Response to Request for Additional Information for the Review of
COBRA-FLX: A Core Thermal-Hydraulic Analysis Code
Topical Report

AREVA NP Inc.

Responses to Requests for Additional Information (RAI)

Figure Q1-1: Subchannel Identification Around The Limiting Channel

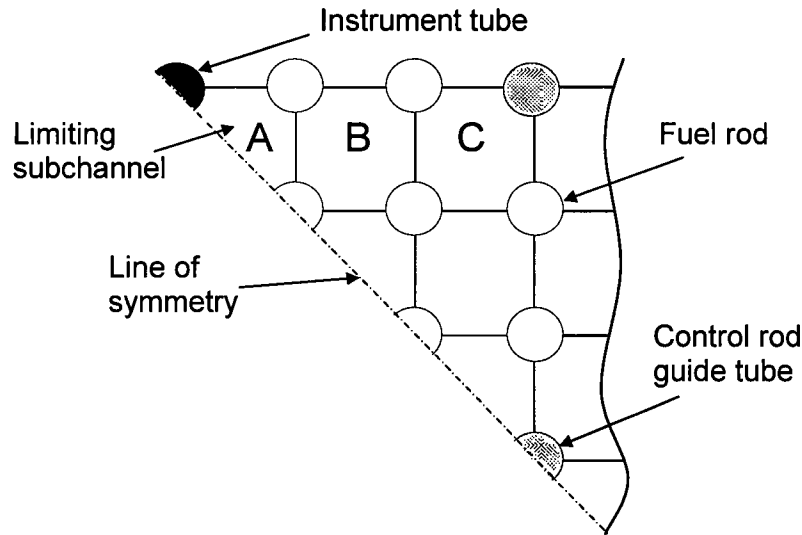
(Verification of Solution Methods) The documentation provided in the above mentioned report does not fully demonstrate that the two solution methods under review (referred to as the SCHEME-Pressure (P) solution method and the Pressure-Velocity (PV) solution method, or more simply as the (P) solution method and the (PV) solution method), yield the same results for the same boundary conditions and model geometry. Section 5.1 Conservation of Mass and Energy, does not provide a meaningful comparison of the results obtained with the two solution methods for the four different modeling geometries considered in this analysis. For this evaluation to be complete, it is necessary to show that the two solution methods yield the same results, within convergence limits, for the same geometric models by comparison of flow and enthalpy distributions in both the radial and axial directions. Particular attention should be given to comparisons of the results obtained for the hot subchannel in the hot assembly.

The consistency of the local conditions between the SCHEME-Pressure (P) and the Pressure-Velocity (PV) solution methods is demonstrated by comparing steady-state results from the 12-, 52-, 75- and 7083-channel models. The comparisons are based on all the axial control volumes in the limiting DNB channel (channel with the minimum DNBR), a channel adjacent to the limiting DNB channel, and a channel two fuel pin pitches away from the limiting DNB channel. Figure Q1-1 shows the relationship of the three channels used in this comparison.

Figure Q2-1: Axial Flow Rate Comparisons for Subchannel A (12 Channel Model)**Figure Q2-2: Axial Flow Rate Comparisons for Subchannel B (12 Channel Model)**

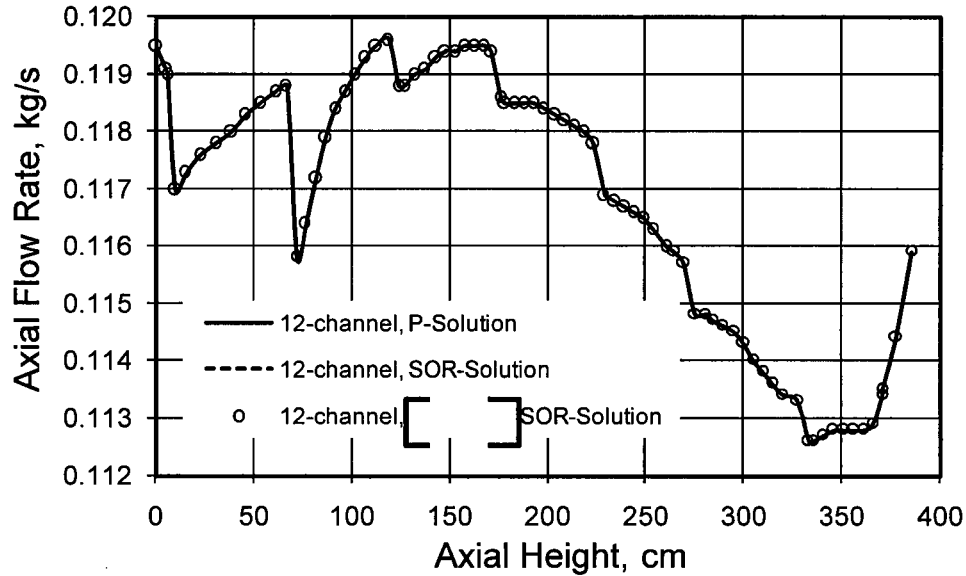
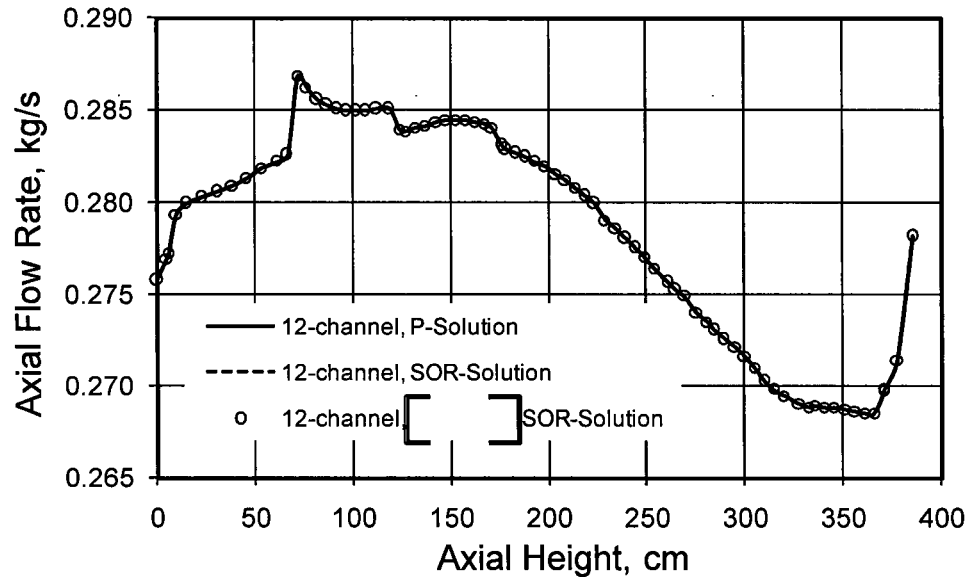
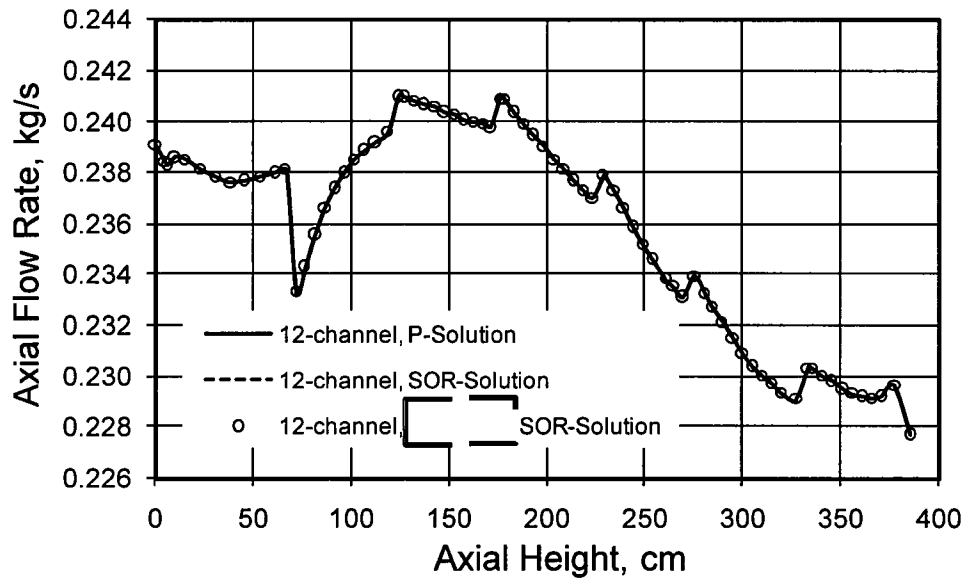
(Verification of Solution Methods) Section 5.4, p. 5-26 and 5-27: It is not explicitly stated in Table 1-1 (p. 1-7) that the optional SOR solver (described in Section 2.3.1.4.1) and the [] SOR solver (described in Section 2.3.1.4.2) are to be included in the scope of this review. However, on p. 5-27, the report states that "The differences between the results of these SOR methods with the P-solution as opposed to the P solution are insignificantly small.... Therefore, the P solution results and conclusions supported by the Section 5.4 validation would be applicable to the SOR methods." Provide qualitative and quantitative technical justification to justify including the SOR solvers as part of the review of the (P) solution method. For this evaluation to be complete, it is necessary to show that

- a. the (P) solution method with its original solver and the two SOR solvers yield the same results, within convergence limits, for the range of geometric models evaluated in Section 5.1 by comparison of predicted flow and enthalpy distributions in both the radial and axial directions.

Figures Q2-1 through Q2-3 show the axial flow rates for the three subchannels used as the basis of the comparison in Figure Q1-1.

These comparisons of the predicted flow and enthalpy distributions in both the radial and axial directions for three different subchannels verify that the three P solution algorithms produce the same results to within the number of significant digits of output.

Figure Q8-2: Forcing Function of the Inlet Velocity for Case 1**Figure Q8-3: Forcing Function of the Inlet Velocity for Case 2**

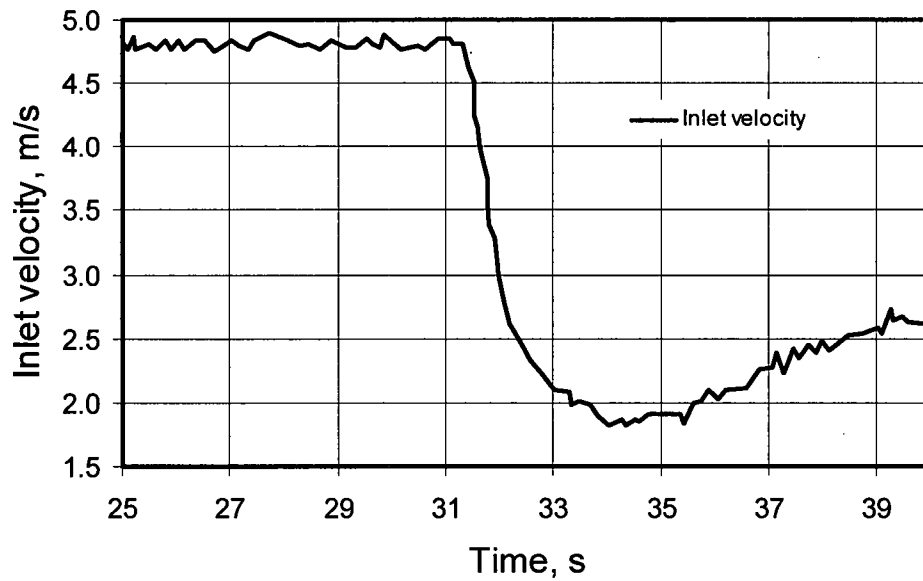
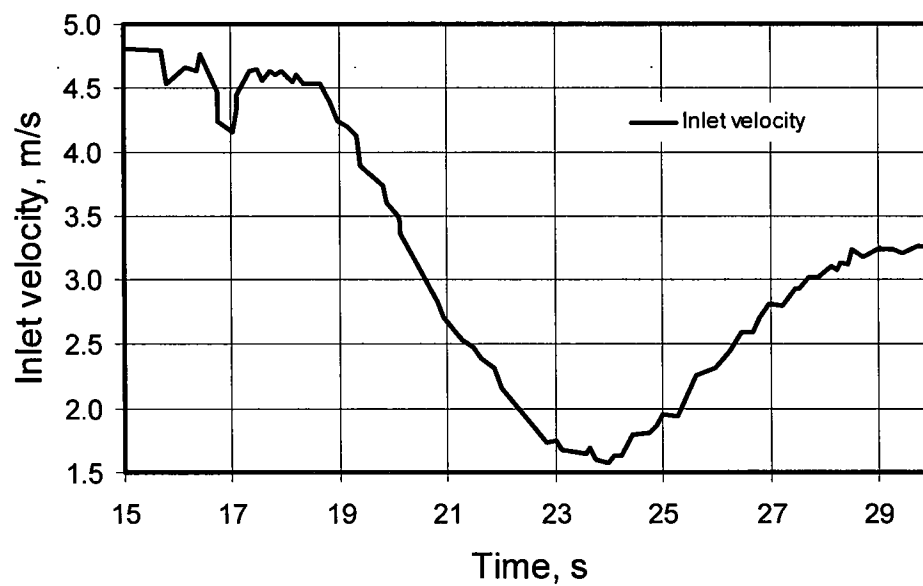
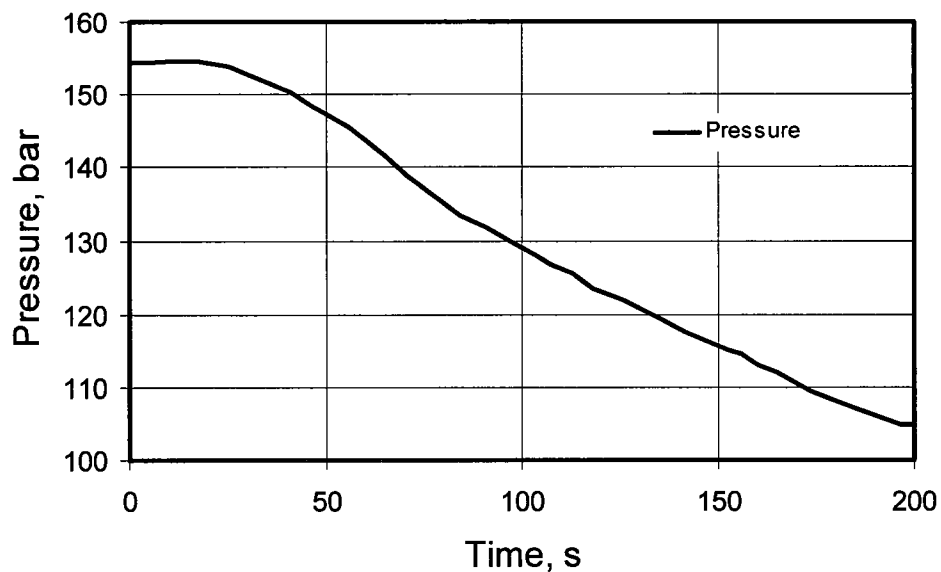
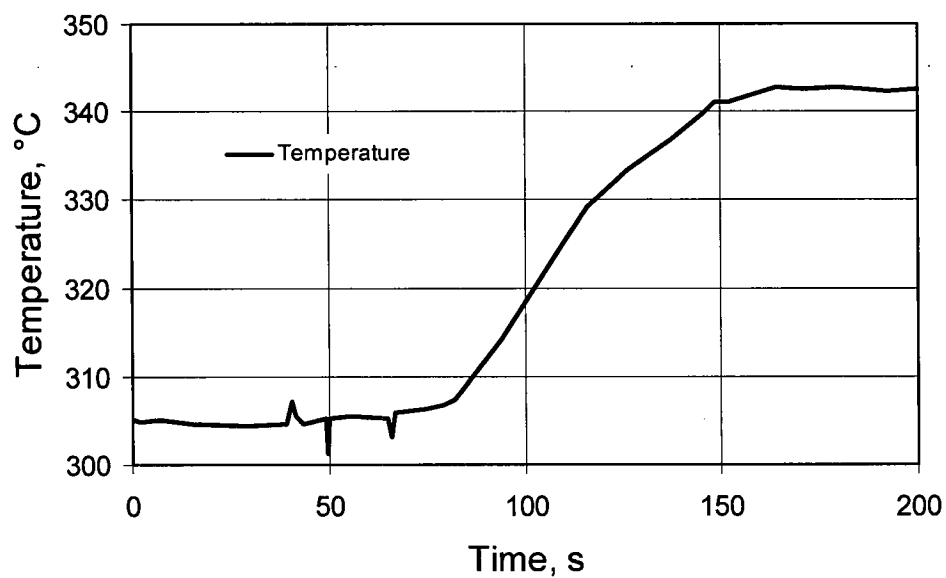
(Validation of Model Components) Section 5.3, p. 5-19 states that empirical correlations included in Table 1-2 have been used with the COBRA 3-CP code, and therefore “no experimental validation is being presented for these empirical correlations.” However, the Chexal-Lellouche bulk void model, as implemented in COBRA-FLX, is not consistent with the model as described in the primary reference¹. In COBRA-FLX, the two-phase flow model consists of three separate components; the void correlation, the correlation for the initiation of subcooled void formation, and the profile-fit correlation relating local quality and void fraction. The specific correlations under review for the two-phase flow model are Chexal-Lellouche (for the void correlation), Saha-Zuber (for the initiation of subcooled void), and Zuber-Staub (for the profile-fit correlation). Saha-Zuber and Zuber-Staub are not the models presented in the primary reference for these components of the Chexal-Lellouche model. Justify the use of Saha-Zuber and Zuber-Staub for these components of the Chexal-Lellouche model

- a. by comparison to the models for these components that are documented in the primary reference
- b. by comparison to relevant experimental data from the primary reference, showing that the void initiation point and the profile-fit obtained with Saha-Zuber and Zuber-Staub, respectively, produce comparable results to those obtained with the primary model

In the following four figures Q8-2, Q8-3, Q8-4, and Q8-5, for each test case the transient varied parameter (forcing function) is given. These forcing functions are also applied to a COBRA-FLX calculation simulating the experiment. Again, in these calculations the models Chexal-Lellouche (for the bulk void correlation), Saha-Zuber (for the initiation of sub-cooled void), and Zuber-Staub (for the profile-fit correlation) have been used.

As it can be seen, COBRA-FLX gives quite reasonable results and the agreement between calculation and experiment can be considered as good.

Figure Q10-1: COBRA-FLX: Comparison of Heat Transfer Correlations, Sieder-Tate and Dittus-Boelter

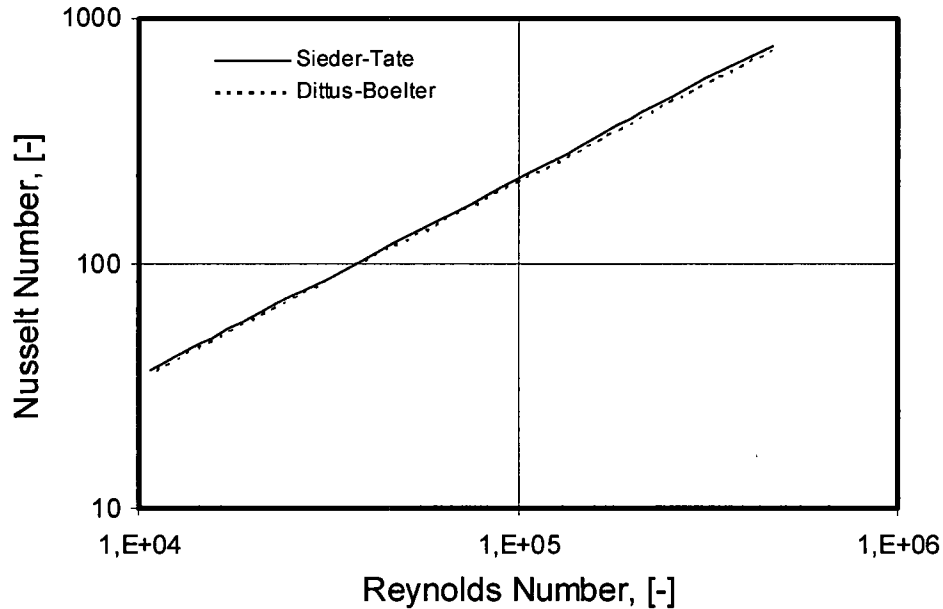
- a. justify the use of the Sieder-Tate heat transfer correlation (p. A-28) for single phase liquid forced convection applications; this correlation was derived as a modification to the Dittus-Boelter heat transfer correlation for high-temperature gas flows.
- b. justify the use of the McAdams heat transfer correlation (p. A-28) for single phase liquid forced convection applications; the formulation provided in the documentation is for natural convection in air.
- c. define explicitly and justify the heat transfer correlations that will be used in post-CHF heat transfer calculations in licensing or safety-related applications with COBRA-FLX. The documentation in Section A.5 on this application is unclear and incomplete.

Figure Q10-1 is based upon the heat flux being set directly proportional to the Reynolds Number in order to keep the power-to-flow ratio constant. The Nusselt Number calculated with the Sieder-Tate correlations are 2% to 4% larger than the values calculated with the Dittus-Boelter correlation for Reynolds Numbers from 10,000 to 470,000.

Based on this comparison, the Sieder-Tate heat transfer correlation is justified for use in typical COBRA-FLX applications.
